## Metro Outer Joint Development Assessment Panel Agenda

Development Description: Multiple Dwelling Development (Brightwater Beaumaris)  
Proposed Amendments: Extension of Time to Substantially Commence  
Applicant: PTS Town Planning Pty Ltd  
Owner: Brightwater Care Group  
Responsible Authority: City of Joondalup  
DAP File No: DAP/18/01484

<b>DAP Name:</b>	Metro Outer JDAP	
<b>Local Government Area:</b>	City of Joondalup	
<b>Proposed Amendments:</b>	Extension of approval for an additional two years to 20 November 2024	
<b>Applicant:</b>	PTS Town Planning Pty Ltd	
<b>Owner:</b>	Brightwater Care Group	
<b>Value of Amendment:</b>	Nil.	
<b>Responsible Authority:</b>	City of Joondalup	
<b>Authorising Officer:</b>	Chris Leigh Director Planning and Community Development	
<b>LG Reference:</b>	DA18/0848.01	
<b>DAP File No:</b>	DAP/18/01484	
<b>Date of Original DAP decision:</b>	30 November 2018	
<b>Application Received Date:</b>	19 September 2022	
<b>Application Statutory Process Timeframe:</b>	60 Days	
<b>Attachment(s):</b>	1. Previous JDAP determination notice and plans (dated 30 November 2018) 2. Location Plan 3. City's Assessment against SPP7.3 (R-Codes Volume 2) 4. Comments / resp

DRAWING			
Site Plan Proposed			
DRAWING NO.	DRAFTER	CHECKED	REV.
D1.02	MK	AW	H

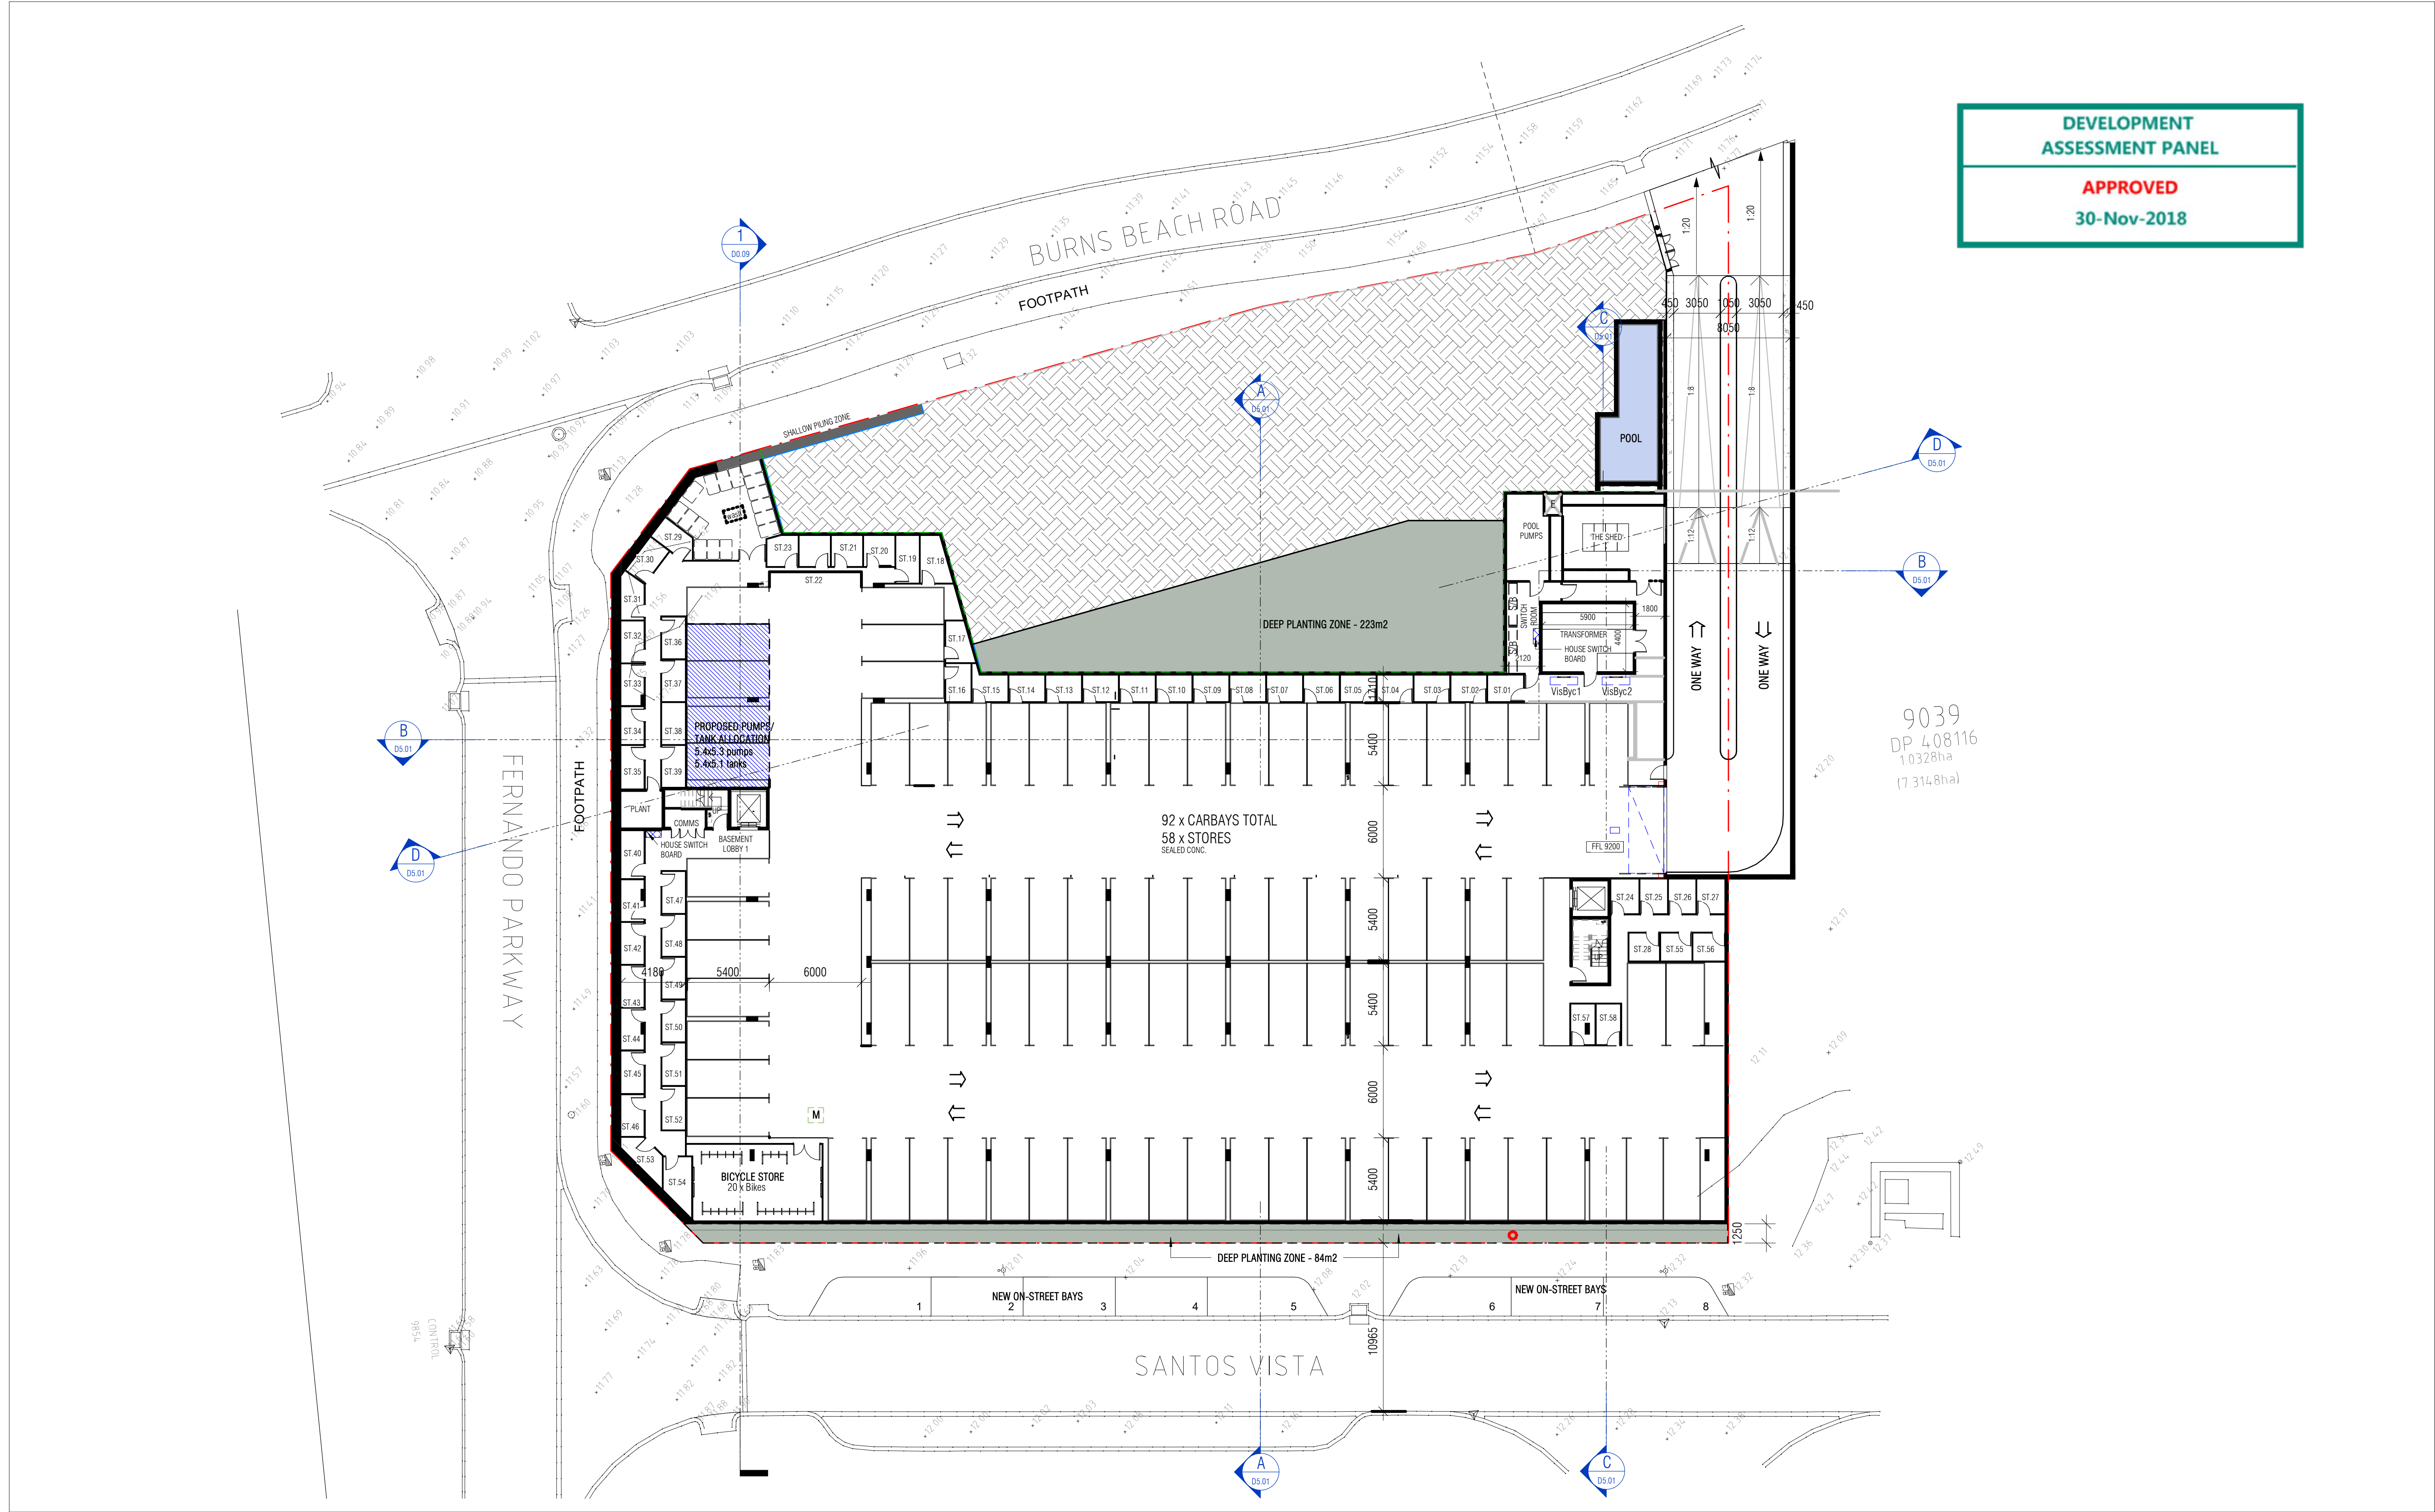
- provide all details relating to paving, treatment of verges and tree planting;
  - remove the 'Hardstand waste bin collection' on the corner of Fernando Parkway and Santos Vista and replace with landscaping;

- a. all waste is to be collected within the basement. No bins are to be placed on the verge for collection;
  - b. the Hardstand – Waste Bin Collection area on the corner of Fernando Parkway and Santos Vista is not supported and is to be removed from the plans;
